REPORT TO APPLICATION DETERMINATION PANEL

2 A Moorilla Street Dee Why - Review of Determination of Application No.2012/1376 for Construction of a dwelling house and secondary dwelling pursuant to SEPP (Affordable Rental Housing) 2009.

REVIEW OF DETERMINATION ASSESSMENT REPORT

Application Number:	REV2013/0059
Responsible Officer:	Daniel Milliken
Land to be developed (Address):	Lot 2 DP 1090825 , 2 A Moorilla Street DEE WHY NSW 2099
Proposed Development:	Review of Determination of Application No.2012/1376 for Construction of a dwelling house and secondary dwelling pursuant to SEPP (Affordable Rental Housing) 2009.
Zoning:	LEP - Land zoned R2 Low Density Residential
Development Permissible:	Yes
Existing Use Rights:	No
Consent Authority:	Warringah Council Application Determination Panel
Land and Environment Court Action:	No
Owner:	Mr Rui Qiang Qiu Mrs Shao Xia Lu
Applicant:	Mr Rui Qiang Qiu
Application lodged:	21/06/2013
Application Type:	Local
State Reporting Category:	Refer to Development Application
Notified:	06/08/2013 to 21/08/2013
Advertised:	Not Advertised in accordance with A.7 of WDCP
Submissions:	7
Recommendation:	Approval
Estimated Cost of Works:	\$ 890,000

SOUTH ELEVATION

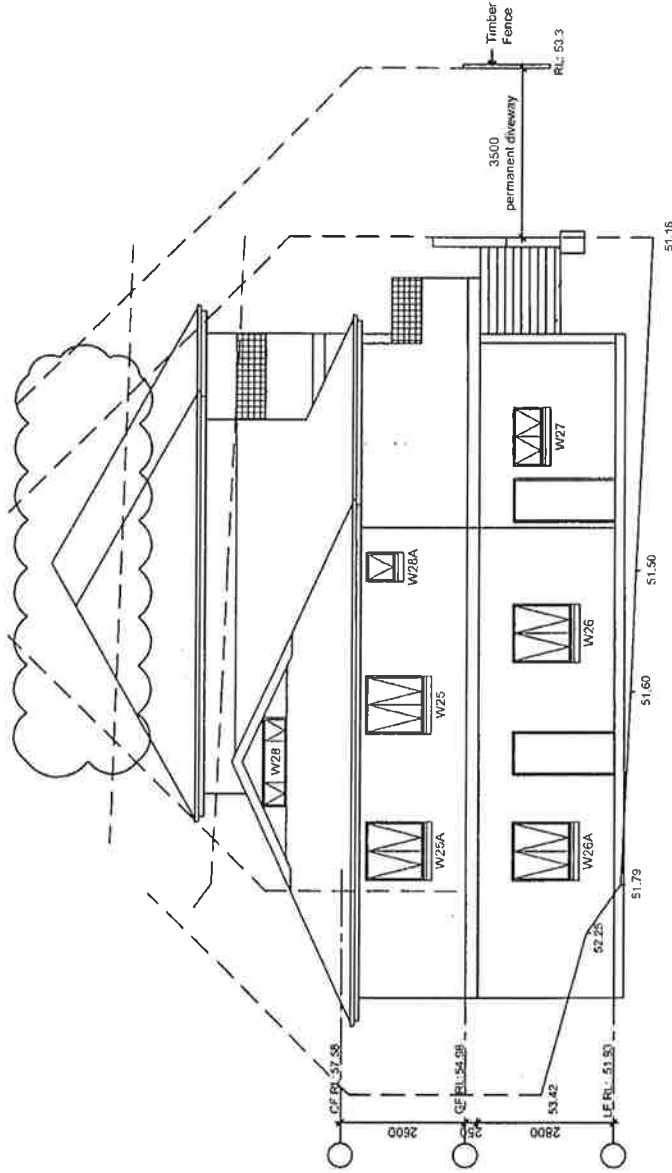
Comment: The proposed 2.0m setback, while compliant with the controls, will result in privacy concerns from the first floor windows. This is discussed under Clause D8 Privacy in this report. In summary, subject to conditions, the privacy impacts are acceptable and the setback complies with the control. Therefore, this matter is not considered to warrant refusal of the application.

- The first floor windows on the southern elevation labeled W25A and W25 on the approved plans are to have a minimum sill height of 1.65 metre when measured from the finished floor level.
- The stairwell window on the western elevation labeled W33 on the approved plans is to entirely consist of obscure or frosted glass.
